Nomination for Waters
Important to Anadromous Fish

ANADROMOUS WATERS CATALOG/ATLAS
CORRECTION FORM

WATERWAY NUMBER: 111-50-10620, 2016 & 2020

DESCRIBE CHANGE(S): Revise hydro as shown on
attached photo. delete stream 111-50-
10620-2020. Shorten 111-50-
10620 & 10620-2016. as shown

jordanBJGlynn.jpg

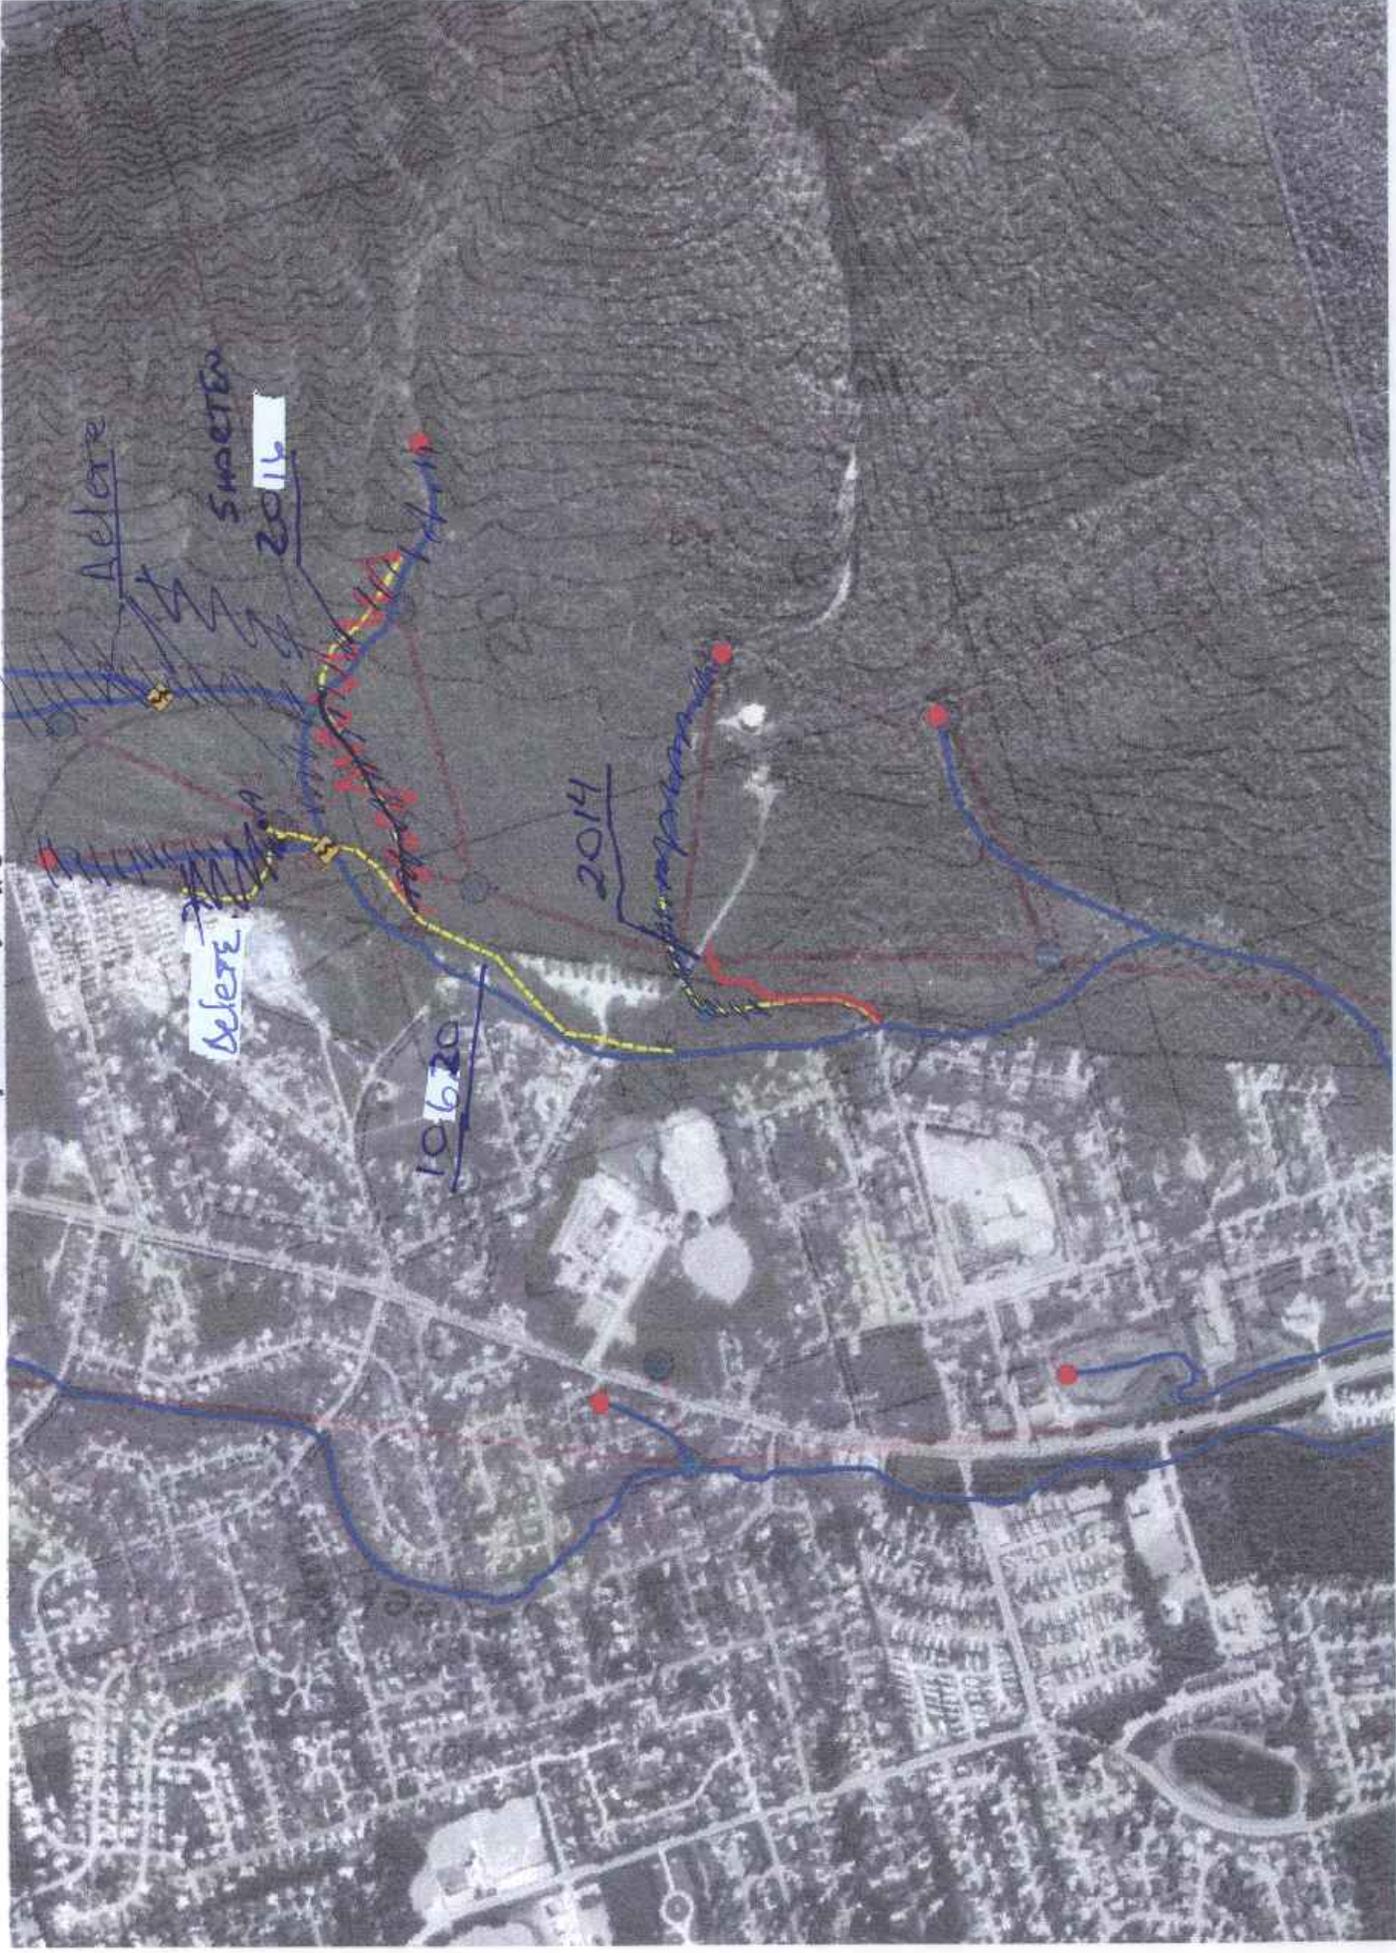
Shorten 10620 to point "A". Remember upper portion Fork to 2019
 Deleere 2020 ~~to~~. Shorten 2016

JordanCreek_Label14.jpg

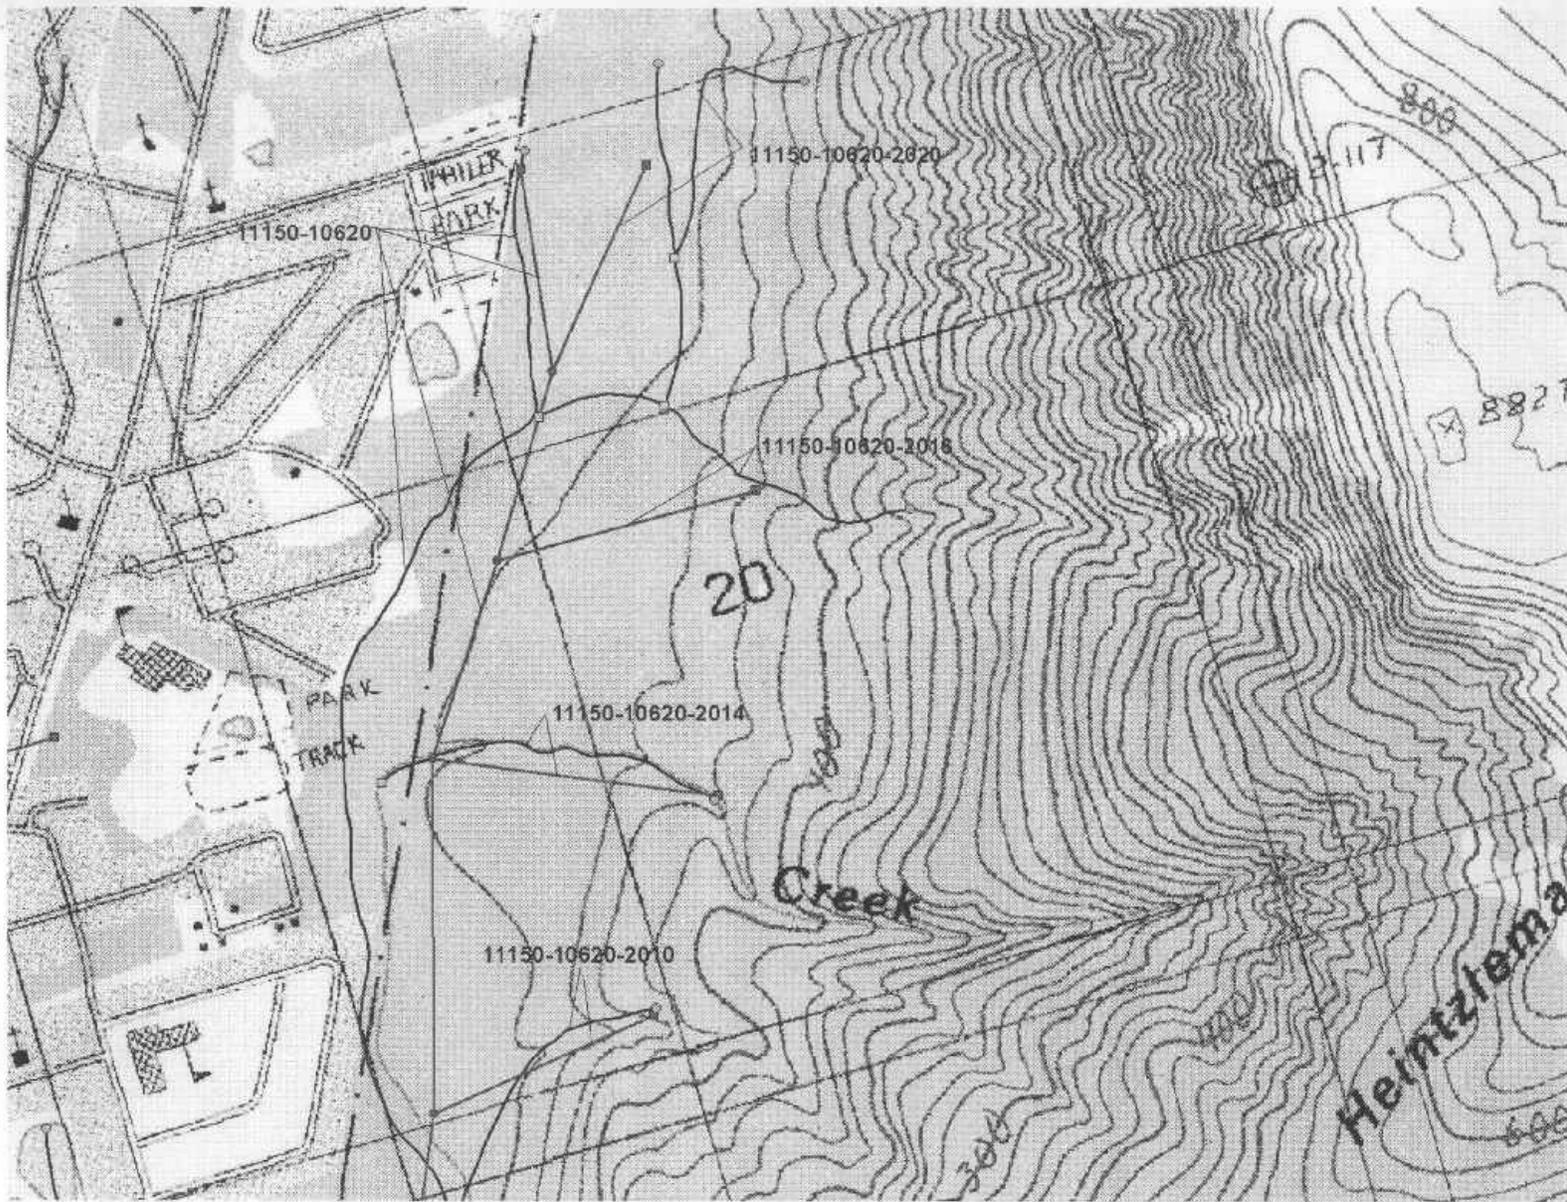
Ben attached is a JPEG which shows the upper end of Jordon Creek. The red straight lines represent where the current 1998 AWC points lie. The dark blue lines represent the new arcs taken from USFS, USGS and DFG digitized hydro. Please feel free to mark it up and send it back with your changes. A couple of points that I can see which need clarification are:

Which of the forks at the upper end do we want represented as the upper extent of Jordon Creek?

Which of the dark blue forks at the upper end of 2020 is 2020?

How does the hydro look in terms of accuracy. It was mostly taken from the newer DLG's or USFS hydro. However, the portion adjacent to the trailer court (currently labeled as the upper end of Jordon Creek) was digitized by us based on the field sketch. Let me know if we need to make adjustments.

JordanCreek_Labels.jpg

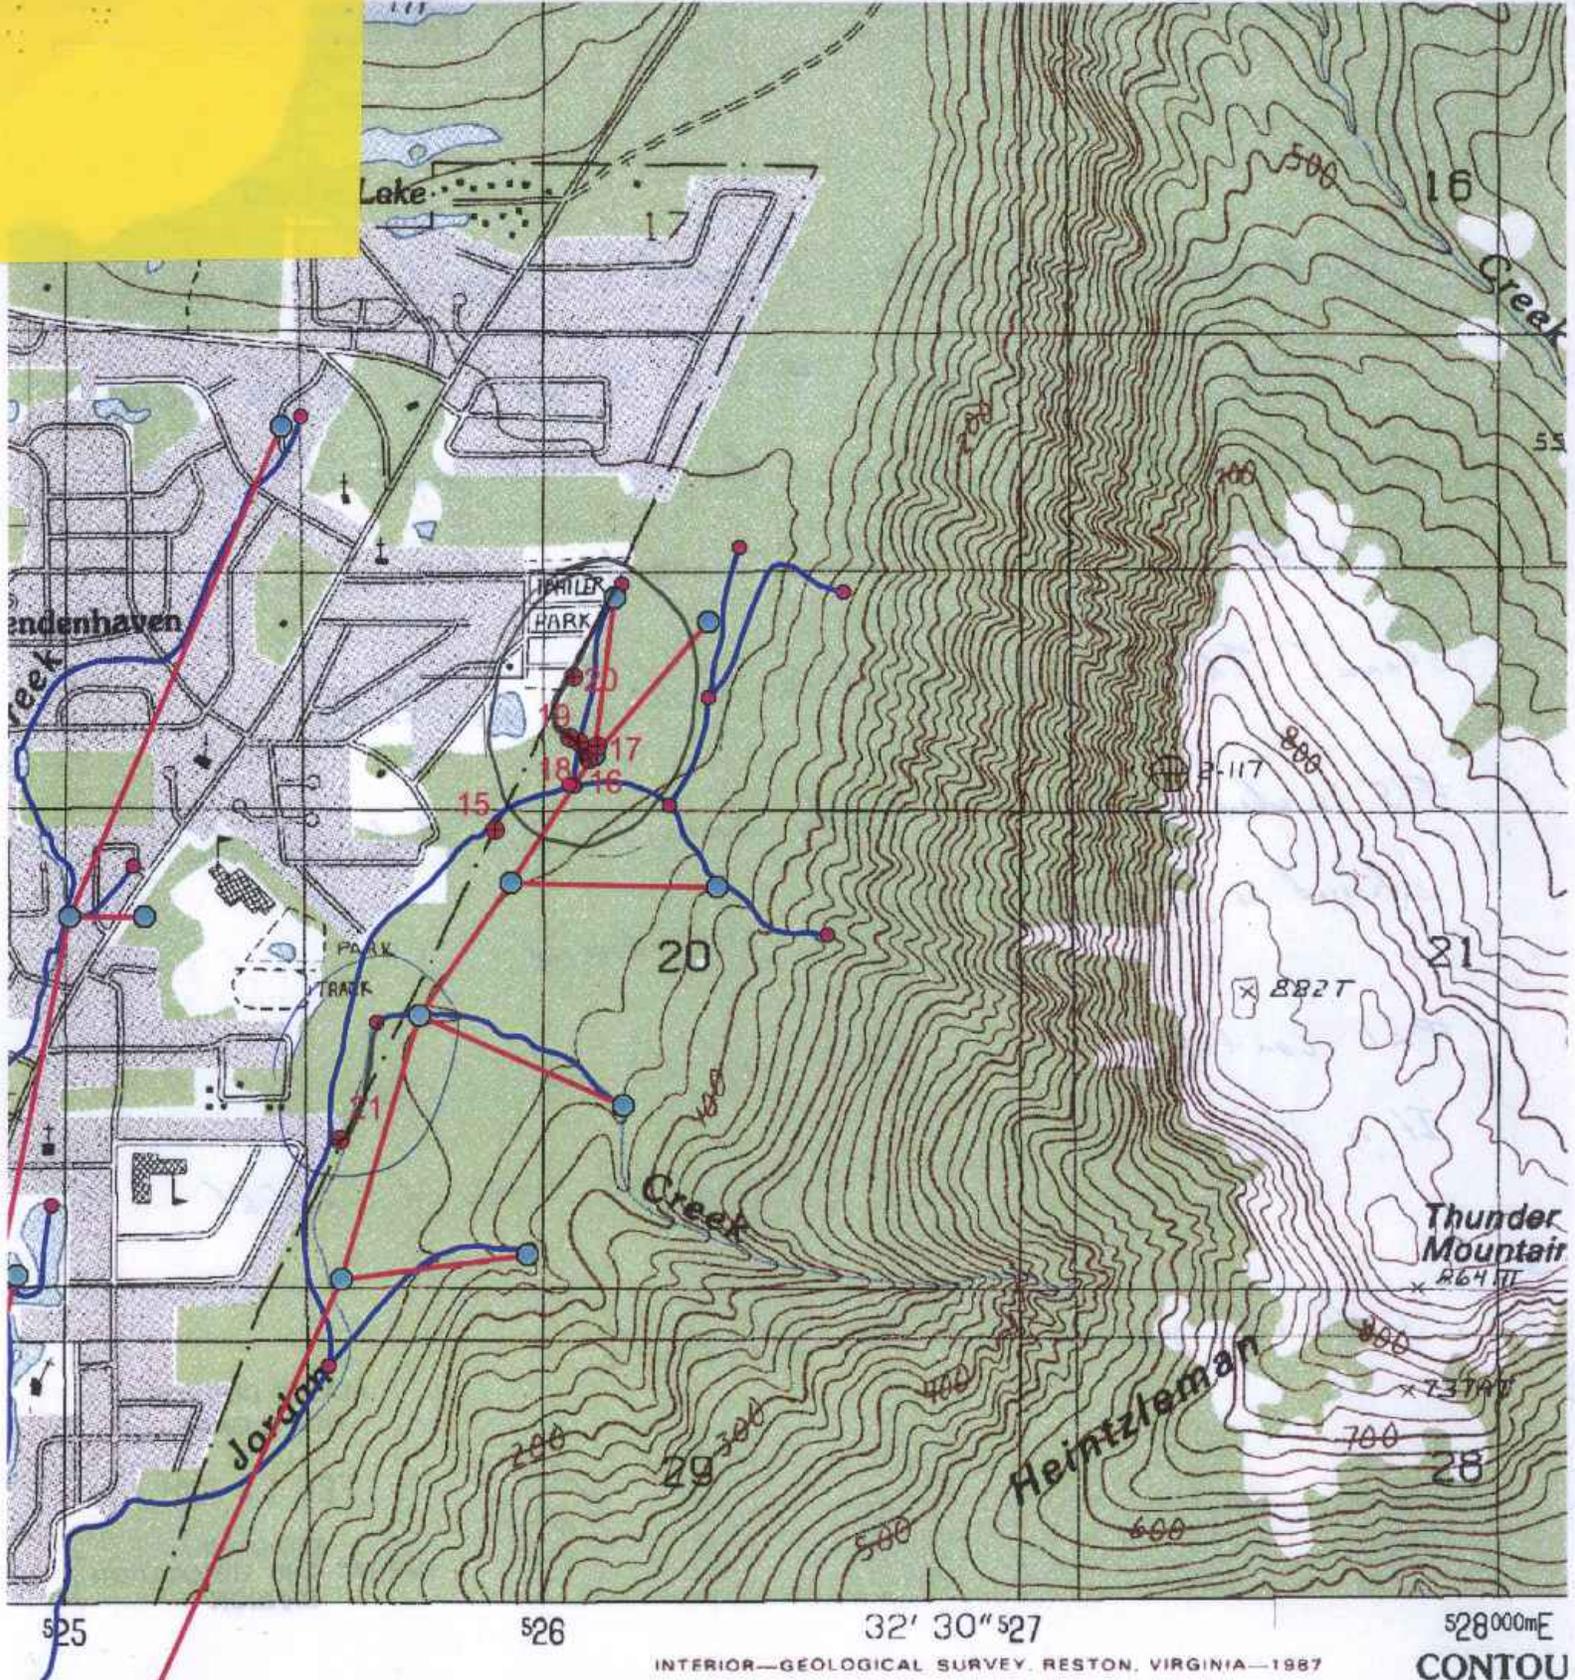
* Which of the forks at the upper end do we want represented as the upper extent of Jordon Creek?

* Which of the dark blue forks at the upper end of 2020 is 2020?

* How does the hydro look in terms of accuracy. It was mostly taken from the

newer DLG's or USFS hydro. However, the portion adjacent to the trailer court (currently labeled as the upper end of Jordon Creek) was digitized by

us based on the field sketch. Let me know if we need to make adjustments.

The # points are GPS locations. I penned in a correction on the upper channel by the trailer park. #17 is the upper limit of fish habitat past the confluence of the channel from the trailer park. It only goes ~150' before becoming a forested marshy area w/ no defined channel. Those channels east of the trailer park are tertiary.

#15 is where another channel enters Jordan Cr, but it has not been cataloged as yet, though fish have been observed.

#21 conformed the confluence w/ the marked channel.

It is degraded by excess sediment, but remains fish habitat.
